Access Compliance Report

Public Rights-of-Way

(Curb Ramps)

Intersection ID: 28255	Main Street: REA_RD	Cross Street: ARDREY_KELL_RD	Location: SE
ADA ID: B974E7D046E9	Ramp Type: Perp	Initial Pass/Fail: Fail	Overall Compliance: No
Codes/Mitigation Info/Possible Solution			Severity Score: 10
			Field Measurements/Component Compliance

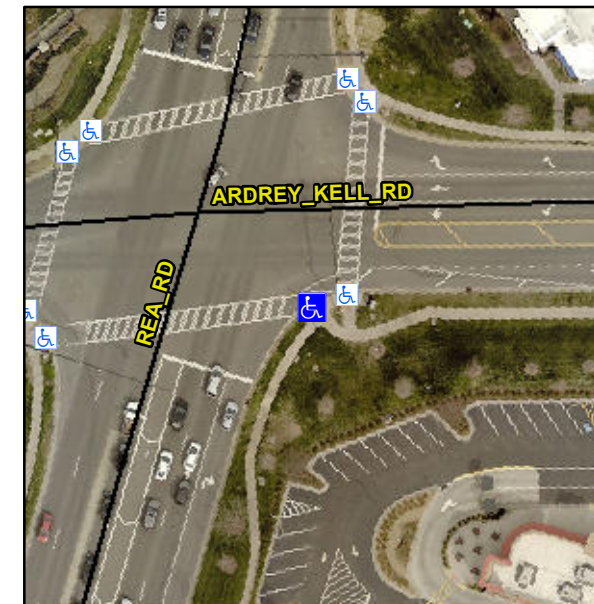
R304.5.1

Compliance	Description	Data	Compliance	Description	Data
N/A	Ramp Length (in)	136.0	Yes	Ramp Slope (%)	8.3
No	Ramp Width (in)	47.0	Yes	Ramp XSlope (%)	3.4
N/A	Flare Type LT	N/A	N/A	Flare Type RT	N/A
N/A	Flare Slope LT (%)	N/A	N/A	Flare Slope RT (%)	N/A
N/A	Flare Traversable LT?	N/A	N/A	Flare Traversable RT?	N/A
N/A	Landing Length (in)	N/A	N/A	DWS Provided?	N/A
N/A	Landing Width (in)	N/A	N/A	DWS Contrast?	N/A
N/A	Landing Slope (%)	N/A	N/A	DWS Length (in)	N/A
N/A	Landing X Slope (%)	N/A	N/A	DWS Full Width?	N/A
N/A	Landing Curb? (Y/N)	N/A	N/A	DWS Offset (in)	N/A
N/A	Shared Landing?	N/A			
N/A	Gutter Ponding?	N/A	N/A	Gutter Slope (%)	N/A
N/A	Gutter Lip Ht (in)	N/A	N/A	Gutter X Slope (%)	N/A
N/A	Painted X Walk1?	Yes	N/A	Painted X Walk2?	N/A
	X Walk 1 Direction	To W		X Walk 2 Direction	N/A
N/A	X Walk 1 Width (in)	116.0	N/A	X Walk 2 Width (in)	N/A
	X Walk 1 Slope (%)	0.9		X Walk 2 Slope (%)	N/A
	X Walk 1 X Slope (%)	3.6		X Walk 2 X Slope (%)	N/A

Remove & Replace Entire Ramp.
